REMARKS

Drawings

FIG. 4

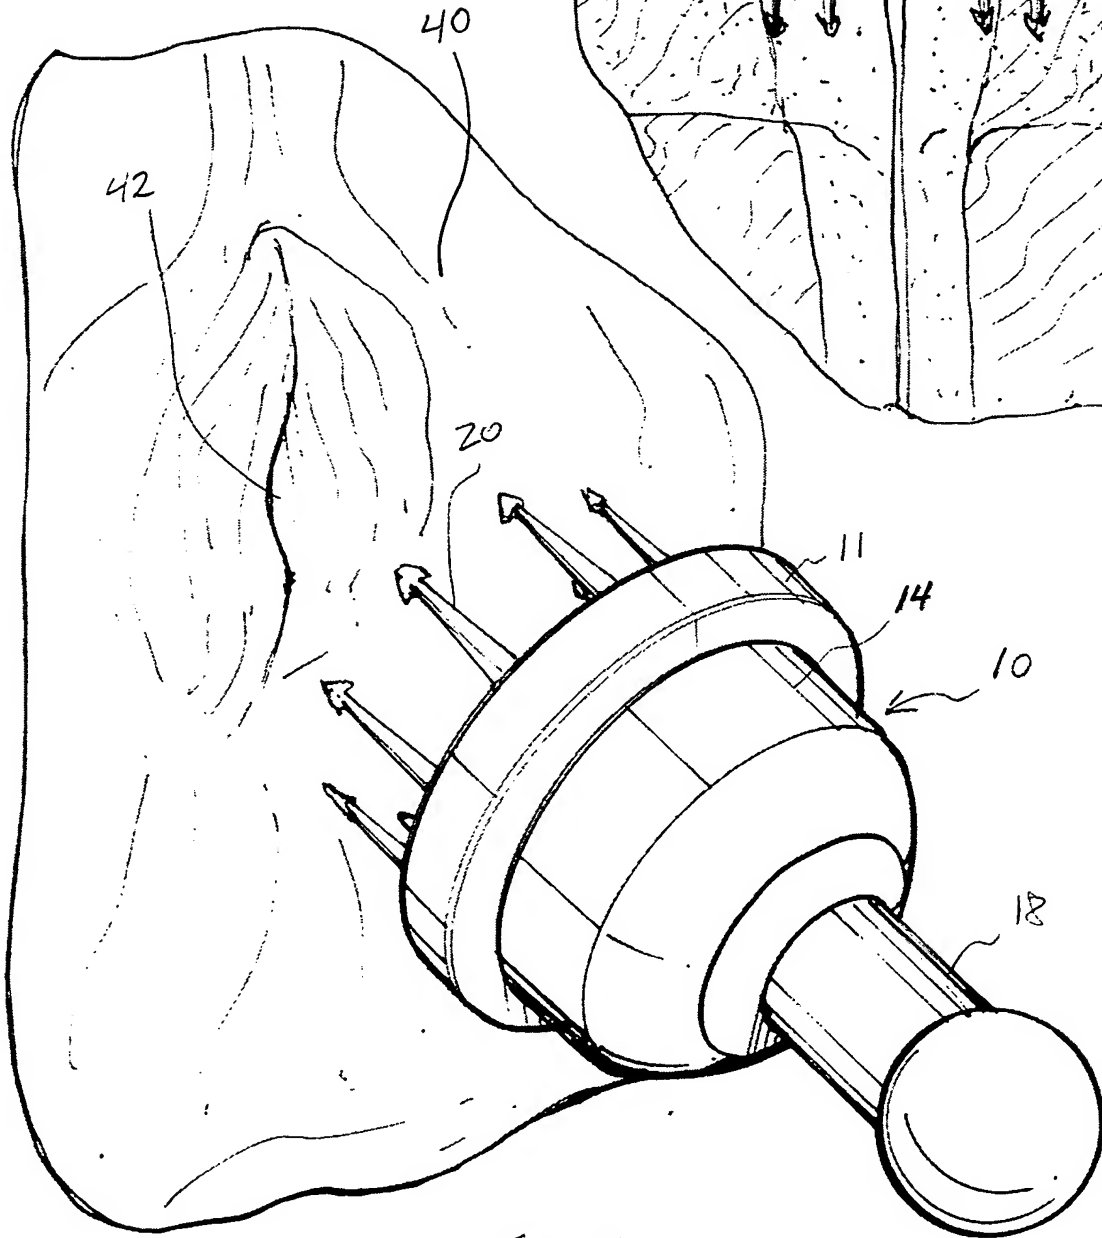
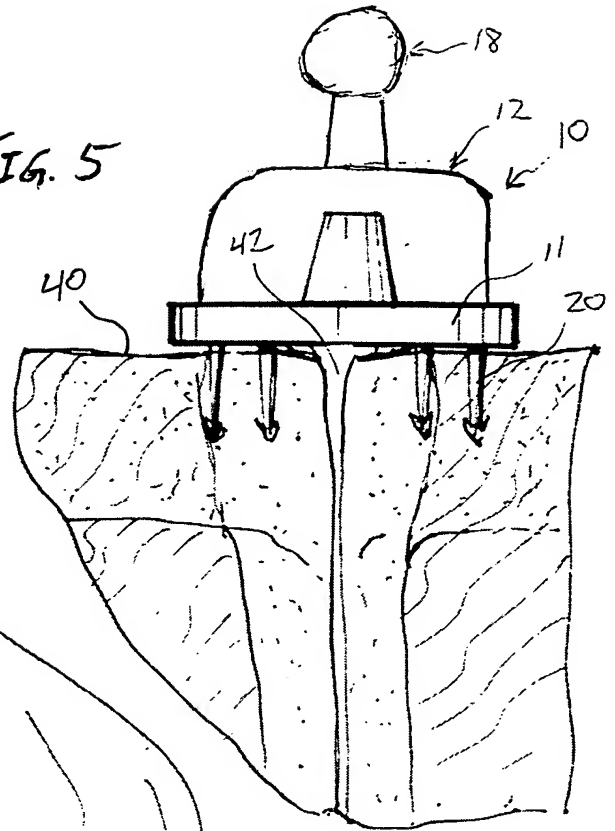
A replacement sheet including FIGS. 4 and 5 are included herewith. Reference numeral 40 indicating uterine tissue has been added as it was unintentionally omitted in the original. The reference numeral 40 is present in the specification on page 11 line 18.

Withdrawal of the objection to the drawings is respectfully requested. Specifically, the Examiner states that the "barbs" claimed in claims 4 and 14 are not illustrated. Applicant points out that the drawings and description show and describe a "barbed head 24". It is believed that a barbed head includes barbs and is adequately shown and described.
